UNITED STATES PATENT AND TRADEMARK OFFICE

APPLICATION NO.	FILING DATE	FIRST NAMED INVENTOR	ATTORNEY DOCKET NO.	CONFIRMATION NO.
09/304,716	05/04/1999	JAMES WILLIAM CREE	4546RC2D	1077

**Office Action Summary**

## DETAILED ACTION

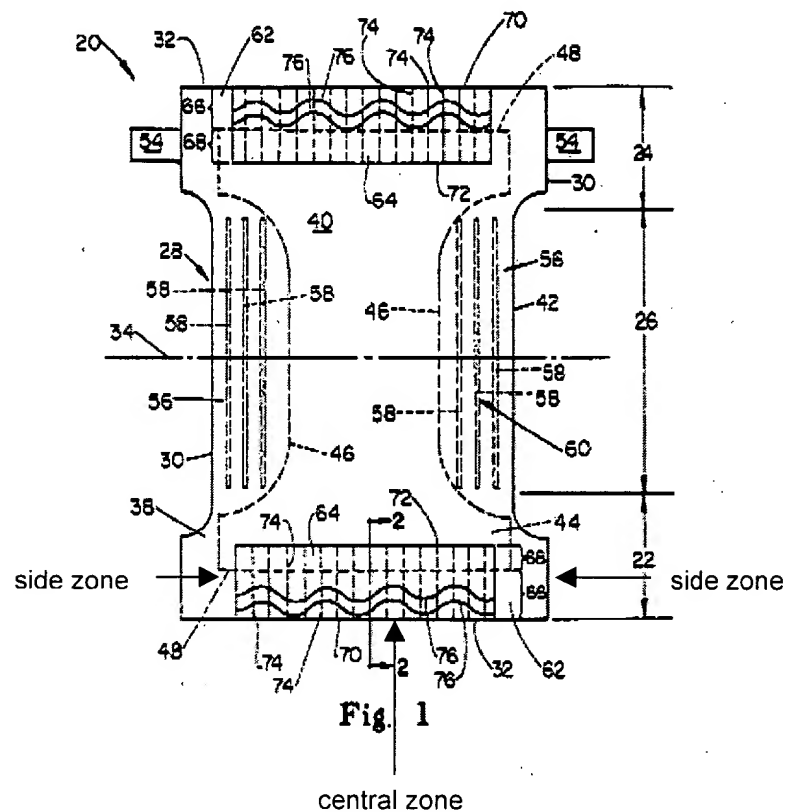
With respect to the applicant's arguments that Freeland does not teach a top layer having a central zone and side zones at both sides of the central zone wherein the

central zone is thicker than the side zones, the examiner again refers to figure 1 as shown below.

The central zone of the top layer is considered to be the combination of layers 38 and 64 as explained in the rejection of claim 6. The examiner notes that figure 2 was referred to in addition to figure 1 because figure 2 provides an enlargement of the details shown as an overview in figure 1. Nonetheless, in figure 1, the combination of layers 38 and 64 do not extend entirely along the end edges of the article. Therefore, each side edge of the top layer that does not include the waistpanel is considered a side zone and the top layer portion that includes the waistpanel is considered as the central

zone. In light of this, Freeland does in fact teach a top layer with a central zone being thicker than side zones.
